CITY PLAN COMMISSION STAFF REPORT

CD-CPC-2026-00028, 00029, 00027

The Hub

Request
Area Plan Amendment
Rezoning
Development Plan (Non-Residential)

sheet
C1.0
Civil
SITE PLAN
permit
25 FEBRUARY 2026

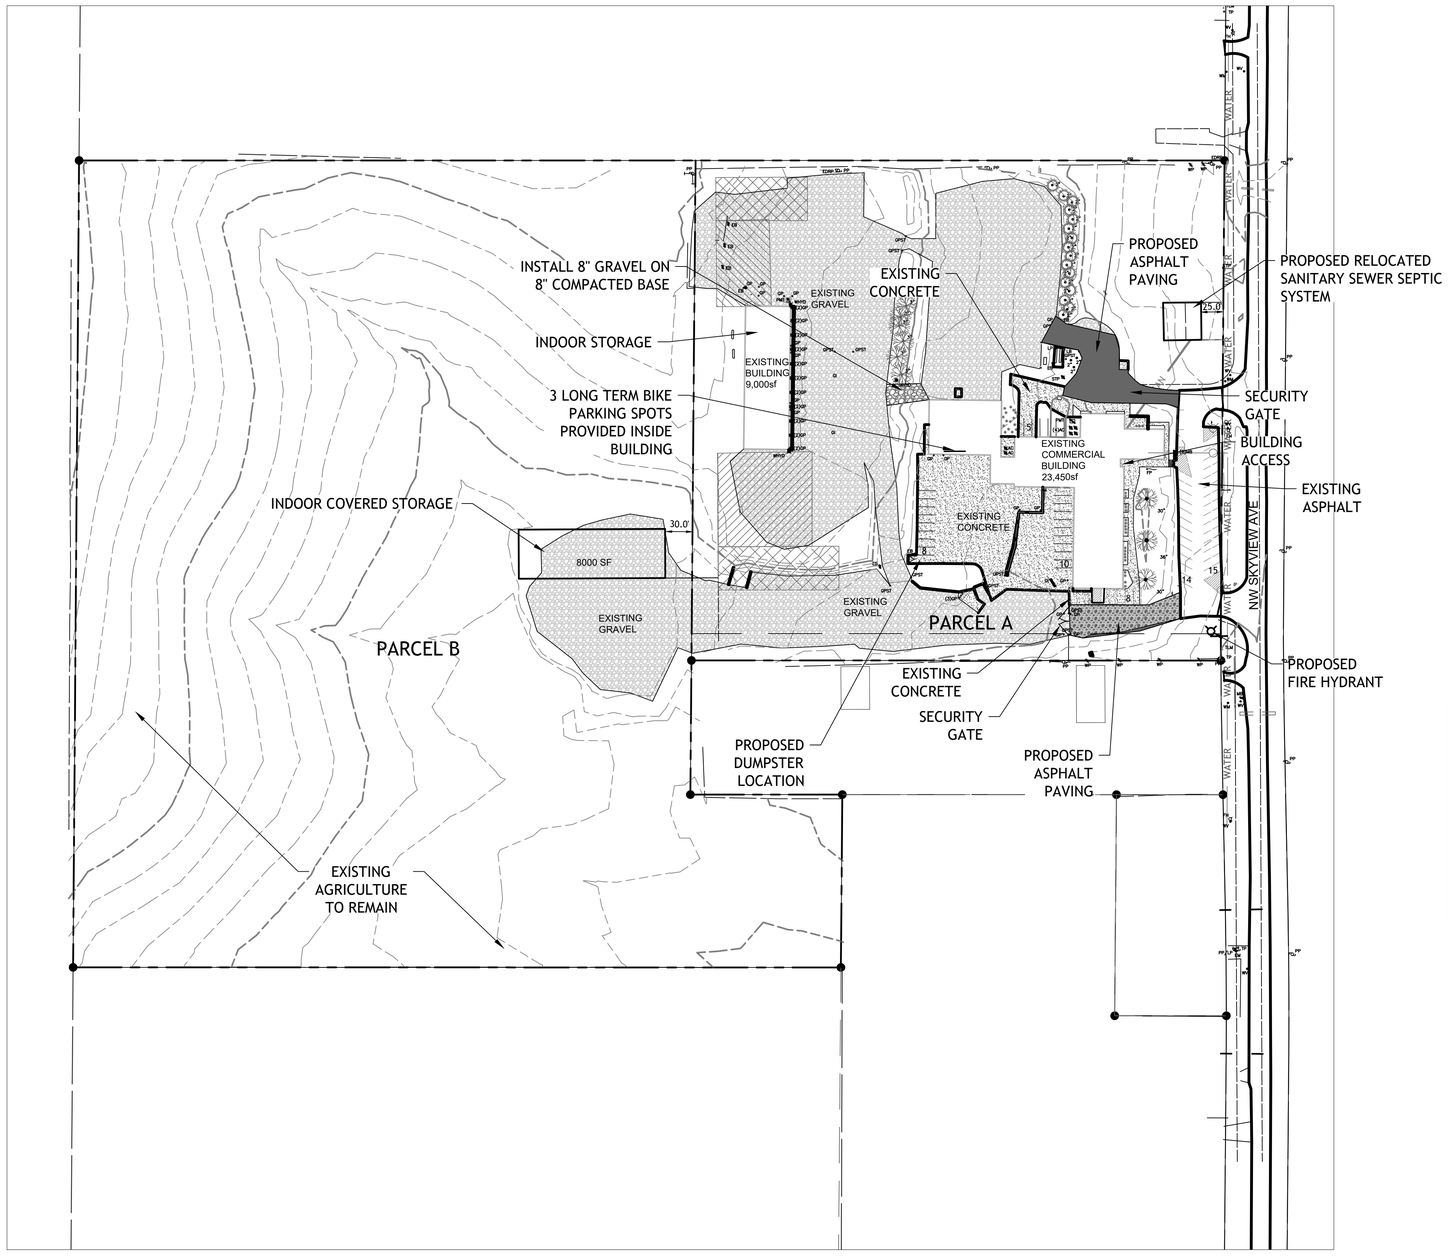
The plan generally complies with the minimum requirements in the Zoning and Development Code. There is a significant amount of gravel currently onsite and indicated on the proposed plan, which the applicant is seeking a variance for if the rezoning to B4 is approved.

The revised plans indicate areas to be paved for accessory outdoor storage of a lesser footprint than the indoor storage areas. There is a condition of approval on this development plan that all outdoor storage must be on a paved surface except the area identified for fire wood and temporary log storage.

There are no proposed changes to the exterior of the former school building. The existing storage building to the west appears to have received permits for construction as a hay barn, which requires one side to remain open. As the structure exists today, it appears to be fully enclosed, which may be an occupancy issue with the Permits Division, in addition to the permit violation for reuse of the former school building without proper change of occupancy permitting. Staff has added conditions to the development plan requiring proper permitting for all structures on the site.

A second proposed storage building is identified on the western parcel and building plans have been submitted and approved, also identifying it as a hay barn, requiring one side to be open; however, no permits have been issued for this building yet.

The majority of vehicular use area on the site currently contains gravel. Gravel is permitted in the AG-R district, but not the B4 district; therefore, the applicant is seeking a variance for approximately 152,220 square feet of gravel vehicular use area.

6. The property owner shall abate all permit compliance violations within 6 months of development plan approval.
7. The property owner must obtain approval of a variance from the Board of Zoning Adjustment to allow gravel in a B4 zoning district within 1 month of rezoning approval from City Council.

8. All motor vehicle repair uses shall be conducted in an permitted structure and not outdoors for more than 24 hours at a time.
9. All storage containers must obtain building permits within 6 months of development plan approval or be removed from the site.

10. All vehicle storage areas on the property must be located at least 500 feet from any R and AG-R district.

sheet
C3.0
Civil
LANDSCAPE PLAN
permit
25 FEBRUARY 2026

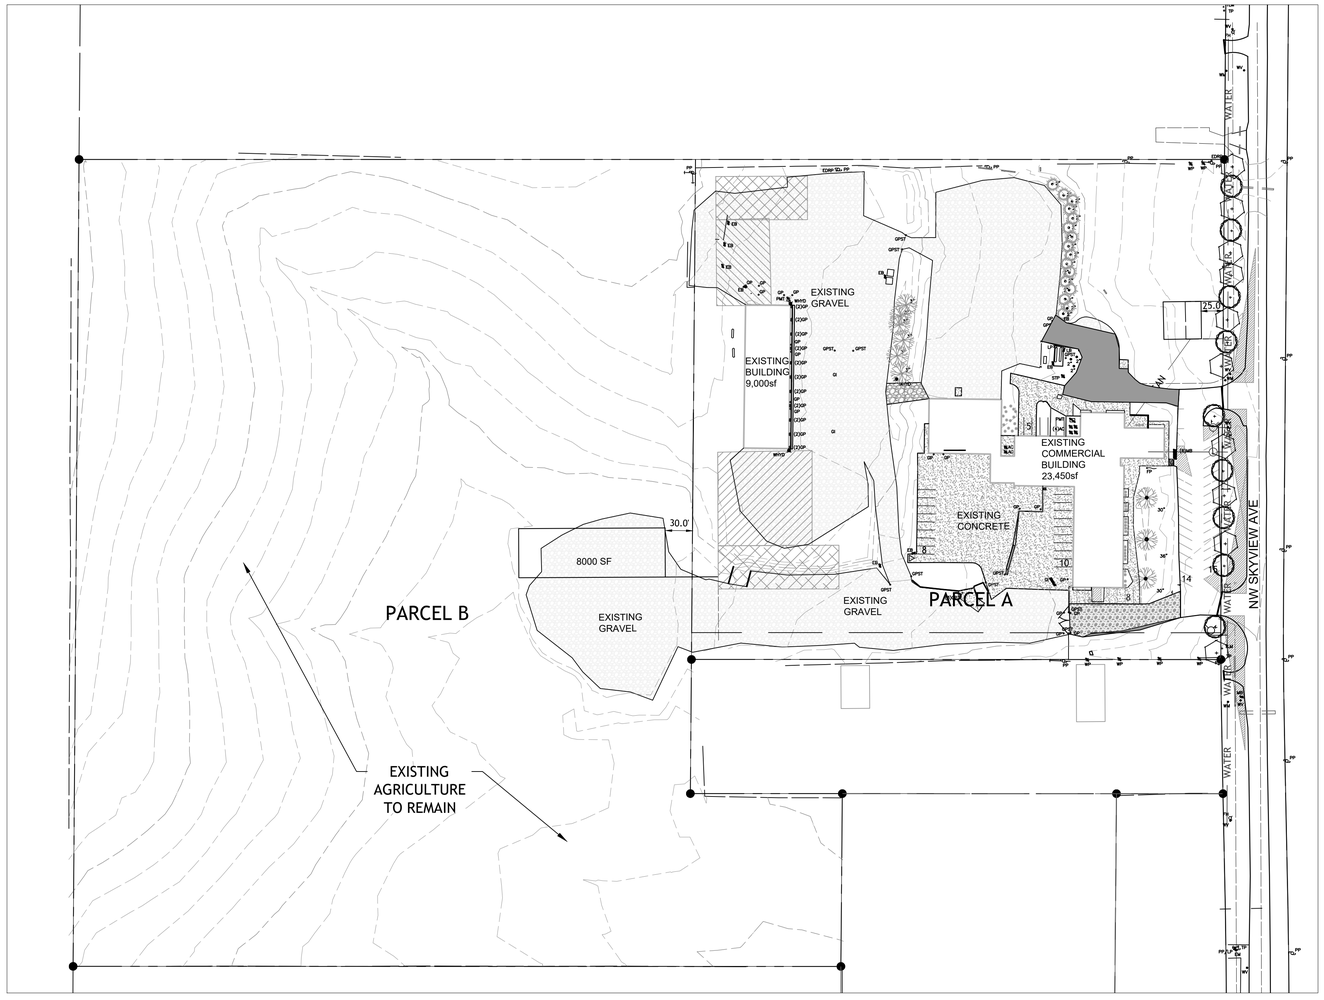
Additional landscape screening will be provided along NW Skyview Avenue to screen vehicular use areas around the site.

No existing trees are identified to be removed.
